February 21, 2008
LIC-08-0015

SUBJECT: Response to Request for Additional Information Regarding License Amendment Request for Proposed Technical Specification Changes for Modification of Containment Spray System Actuation Logic

**RESPONSE TO REQUEST FOR ADDITIONAL INFORMATION
REGARDING LICENSE AMENDMENT REQUEST (LAR)
FOR PROPOSED TECHNICAL SPECIFICATION CHANGES FOR
MODIFICATION OF CONTAINMENT SPRAY SYSTEM ACTUATION LOGIC**

FORT CALHOUN STATION (FCS), UNIT NO. 1

Figure 1 - FCS Sump Temperature With and Without Spray

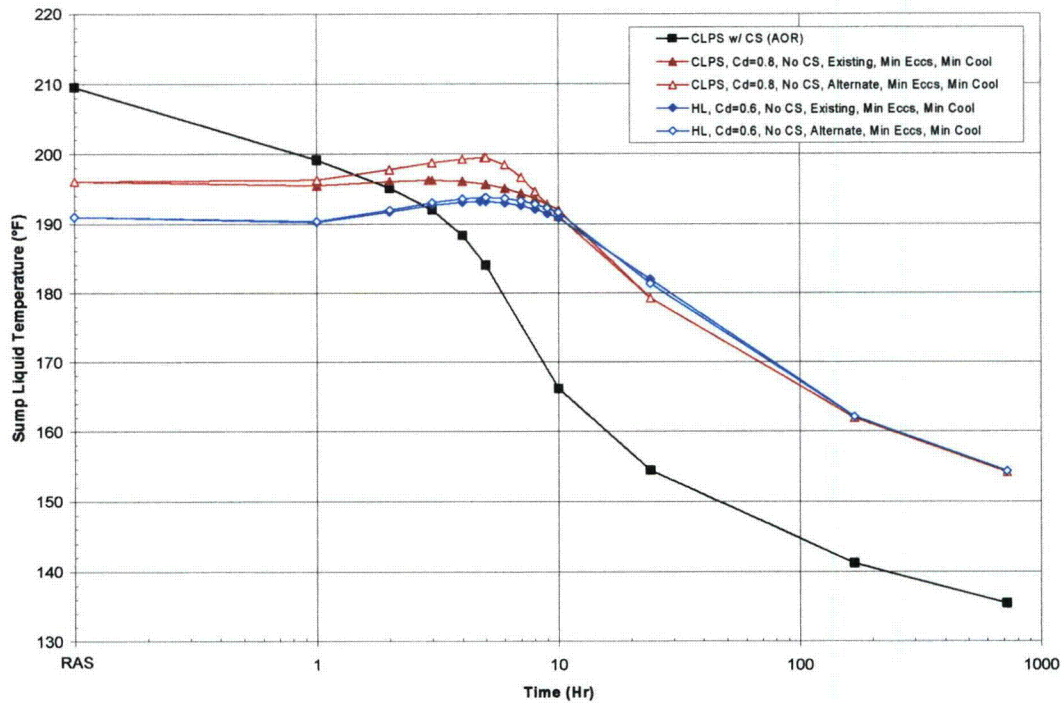
- a. Why were the NPSH analyses performed with the time of transition at recirculating actuation signal (RAS) and the stored energy dissipation rates calculated using the existing method?**
- b. Section 3.5 states that the sump temperatures without containment spray are less than the sump temperatures at RAS from the analysis of record (AOR) with containment spray. Please explain operation of the containment spray including cooling with the shutdown coolers.**
- c. What assumptions are made of the heat transfer between the sump water and the containment atmosphere?**

Additional cases were analyzed to provide a comparison of the impact of the stored energy dissipation methodologies. Figure 1 shows the sump liquid temperature as a function of time after RAS for the analysis of record compared against comparable cases with minimum ECCS flow with stored energy dissipation calculated by the existing and alternate methods. As can be seen, the post-RAS sump temperature response is slightly higher when using the alternate method of calculating the stored energy dissipation rates. The increase in post-RAS peak temperature using the alternate method was approximately 3°F. This small difference does not warrant a change to the arbitrary selection of a stored energy dissipation method, especially given that there was a corresponding increase of overpressure head as can be seen in Figure 6 (refer to the response to RAI #4b for a brief discussion of this plot).

Figure 6 - FCS NPSH Evaluation Without Spray - Limiting Breaks

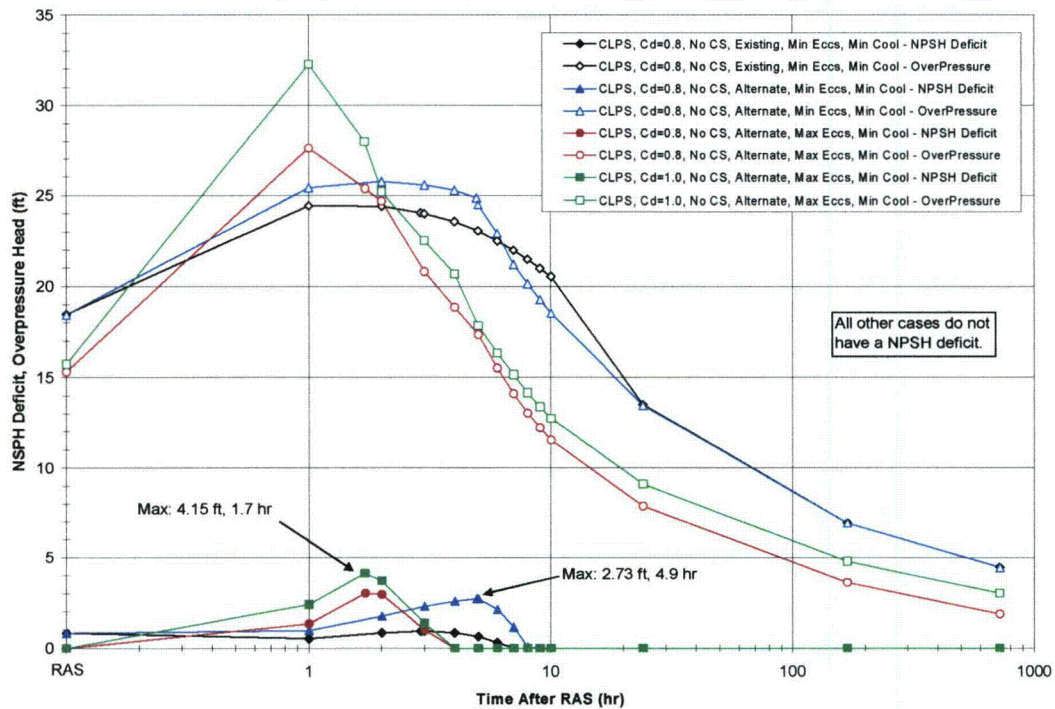
- a. **Please verify that Table 2 applies to the high-pressure safety injection (HPSI) pumps.**
- b. **The NRC staff would prefer to not credit a given amount of containment accident pressure (e.g., 8.99 ft) but rather to simply be assured that there is margin between the calculated containment accident pressure (conservatively minimized) and the pressure necessary to provide adequate available NPSH [net positive suction head] (calculated conservatively). Please provide curves of containment accident pressure as a function of time and the accident pressure necessary to provide adequate available NPSH.**

- b. A comparison of the maximum NPSH deficit, calculated as NPSH Required minus NPSH Available calculated for a containment pressure of 14.2 psia, is plotted along with the available overpressure head in Figure 6. No credit for overpressure head is required for hot leg breaks. A maximum NPSH deficit of 4.15 ft was calculated for which overpressure head is required. Credit for overpressure is required for no more than 9 hours after RAS, which is available for each respective case. Note that the results presented in Figure 6

The limiting case for peak sump liquid temperature and requirement for overpressure credit is a case with maximum ECCS (3 HPSI pumps and 2 LPSI pumps during the Safety Injection phase and 3 HPSI pumps after RAS) and minimum containment cooling (one CACF and two CACs). The overpressure credit is based on maximum allowable head loss across the strainer.

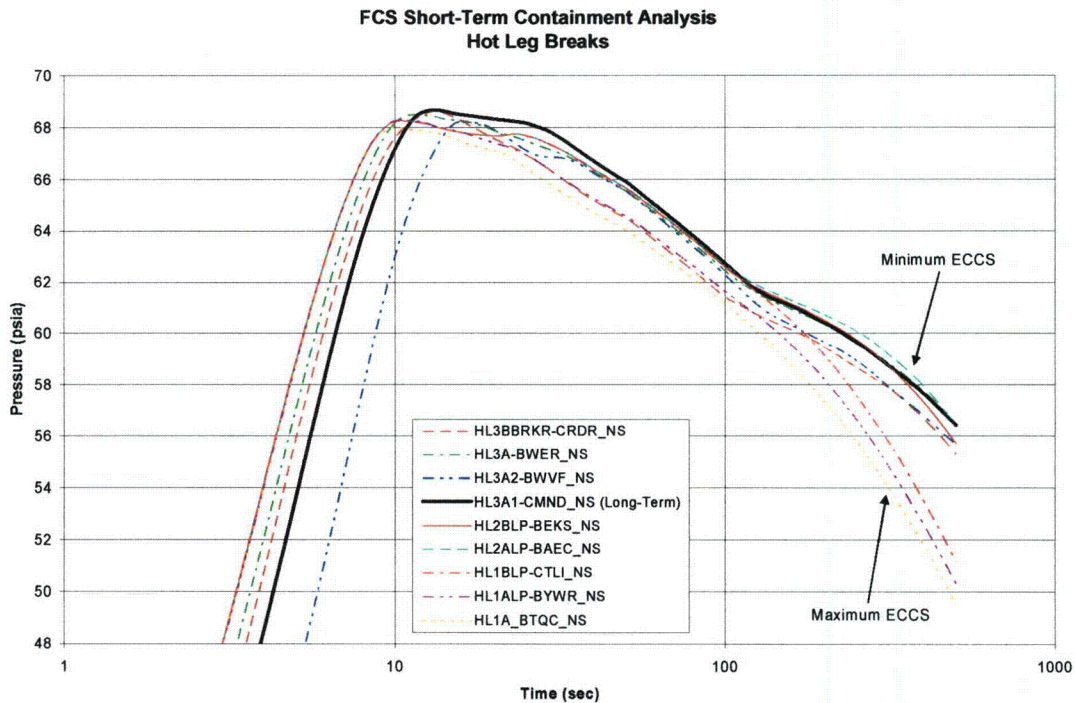
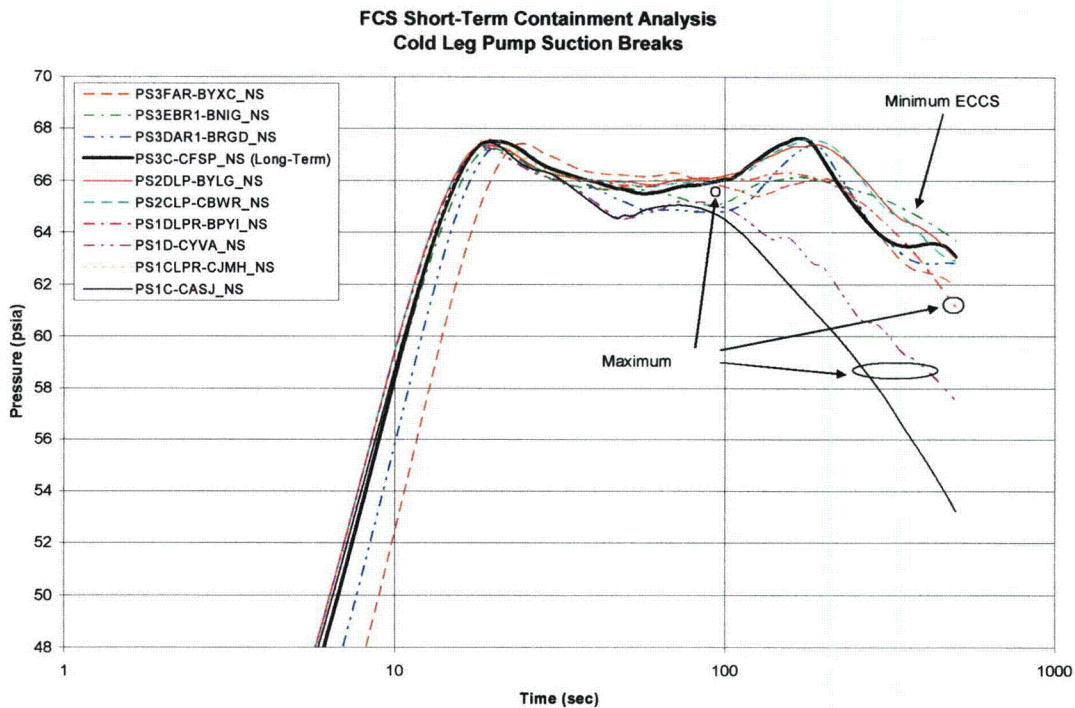
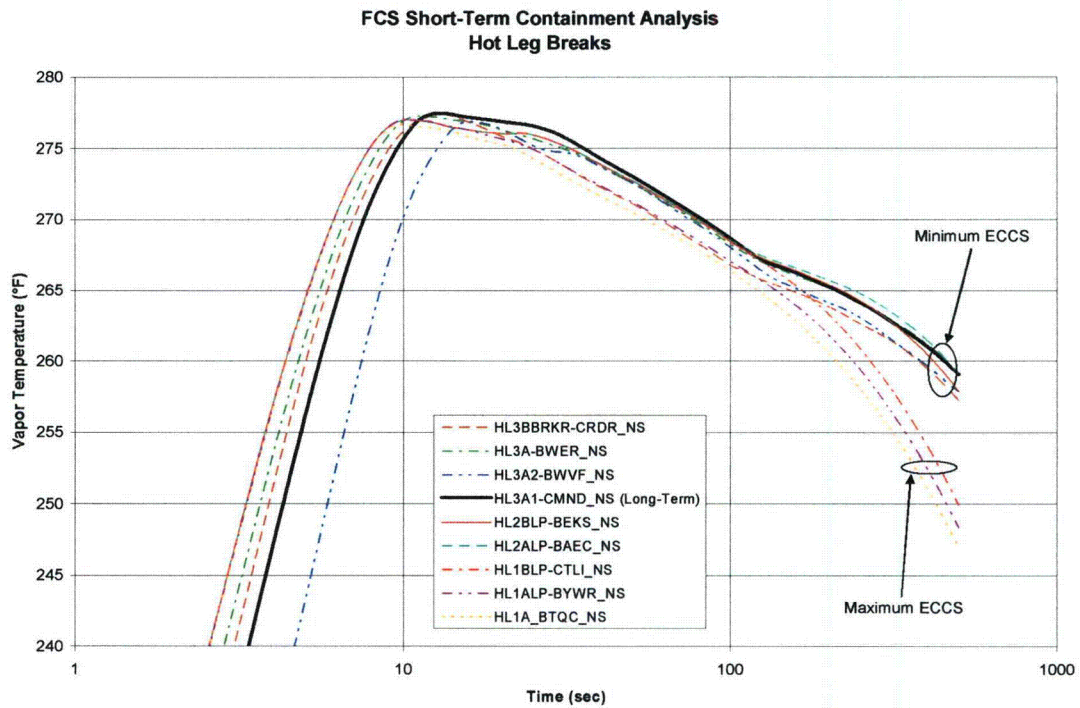
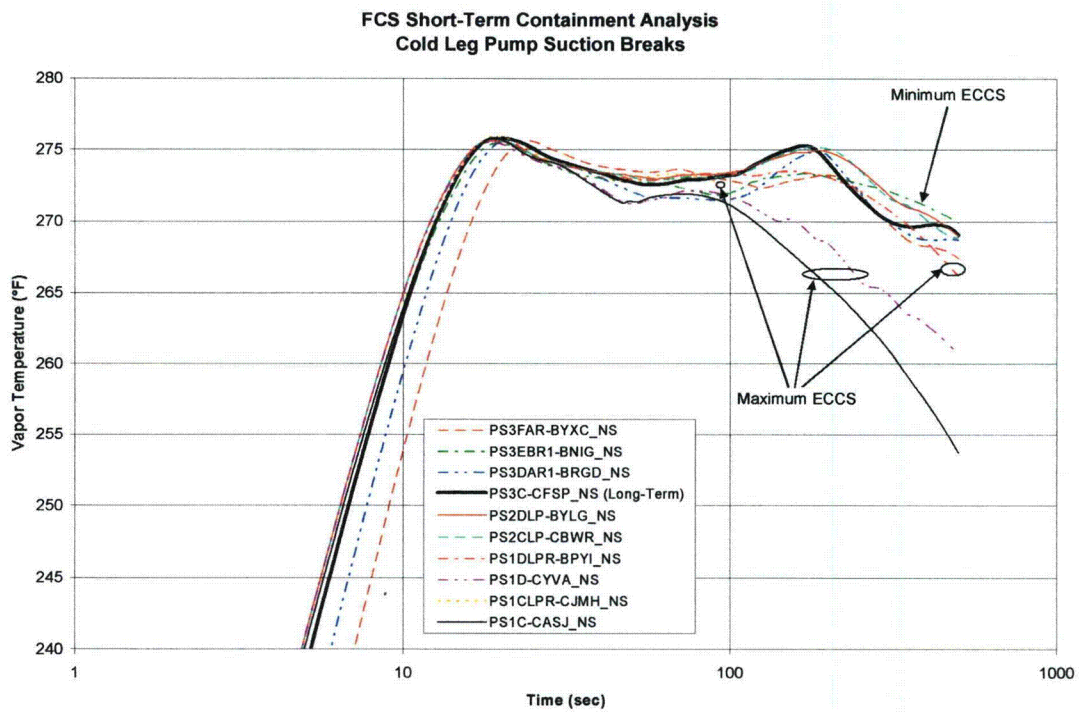
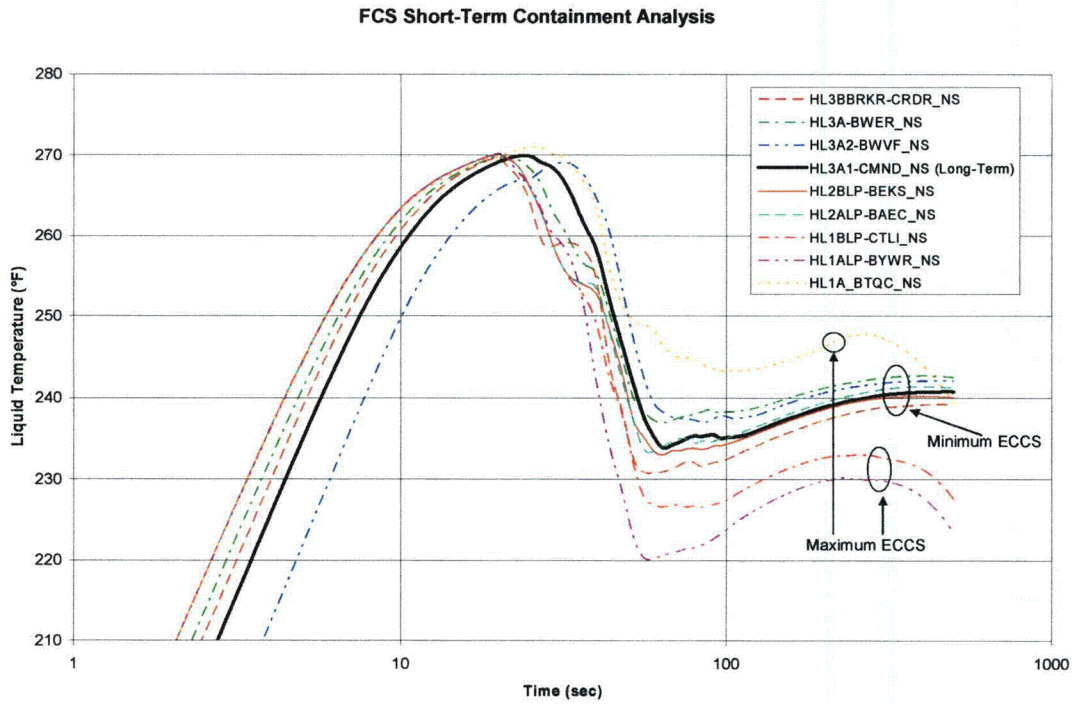
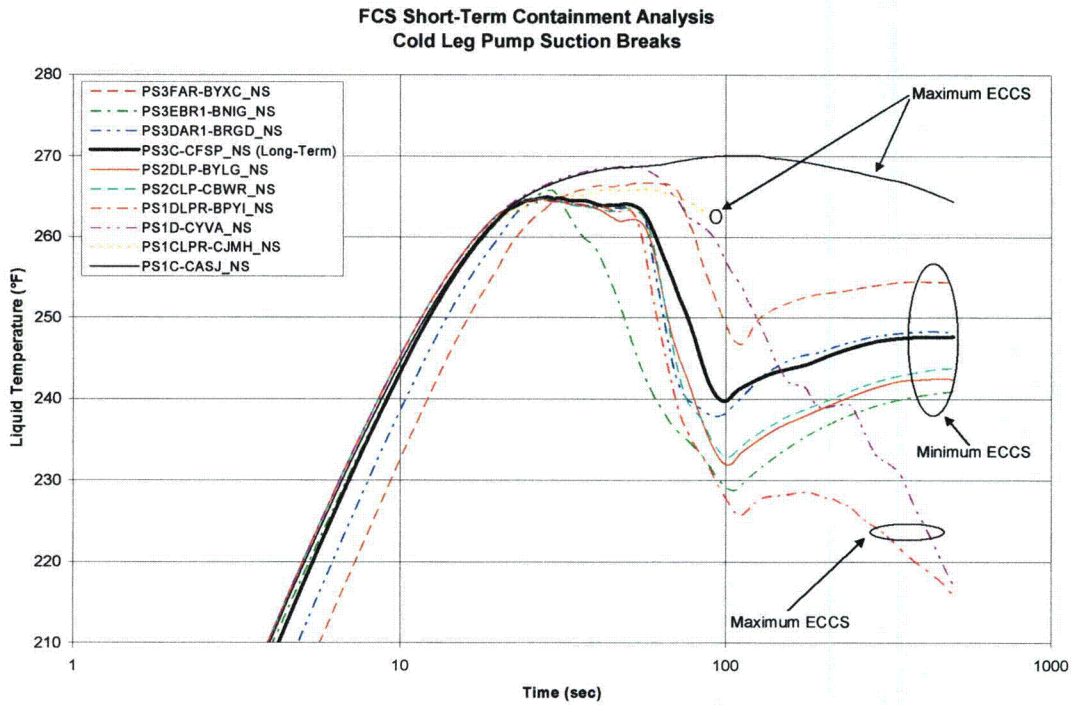
Please explain why the limiting short-term cases are necessarily the limiting cases for the long term.

Containment pressure, vapor temperature and liquid temperature from the short-term cases are shown in Figure 7 to Figure 12 with the cases selected for the long-term pressure and vapor temperature analyses identified for reference. Refer to Table 2 for a brief description of each short-term hot leg and cold leg pump suction break case analyzed. The containment response for large breaks at a given location (e.g., hot leg) and single failure (e.g., diesel generator) evolve to roughly the same containment conditions. As can be seen, the plotted parameters have already started to converge at the end of the ten minutes of the short-term transient analyses and will continue to evolve to approximately the same conditions by RAS because decay heat and sensible heat release rates are similar among classes of breaks. Cases with maximum ECCS do not generate the limiting containment pressure or vapor temperature and can be eliminated for analysis of long-term containment vapor temperature.

Since the release of calculation FC07247, additional long-term cases were performed to further evaluate the long-term sump temperature response. From the short-term analyses, as shown in Figure 12, the sump liquid temperature results from the maximum ECCS cases appear to be divergent with some cases above and others below those of the minimum ECCS cases. Those cases that generated sump liquid temperatures below the minimum ECCS cases were said to evolve to a non-limiting condition because the sump temperature was colder. Cases PS1C-CASJ_NS and PS1CLPR-CJMH_NS are cold leg pump suction breaks that were analyzed without loss-of-offsite power (LOOP) that once the RCPs are tripped the sump temperature will quickly evolve to their comparable LOOP cases because of phase separation in the RCS and lower stored energy dissipation. Because of the potential that higher ECCS flow could result in higher stored energy dissipation rates after the end of the short-term analysis additional cases were performed to evaluate the long-term effect on sump liquid temperature with maximum ECCS flow. The results of these additional cases show that by RAS the higher ECCS flow causes a higher stored energy dissipation rate as compared with minimum ECCS flow. As can be seen in Figure 2 and Figure 3, the sump liquid temperature at RAS is higher for cases with maximum ECCS leading to higher post-RAS temperatures and lower subcooling head as shown in Figure 4 and Figure 5. The shorter time to RAS leads to higher decay heat levels and higher stored energy dissipation that lead to a higher temperature at which the CACs will remove the energy released to containment.
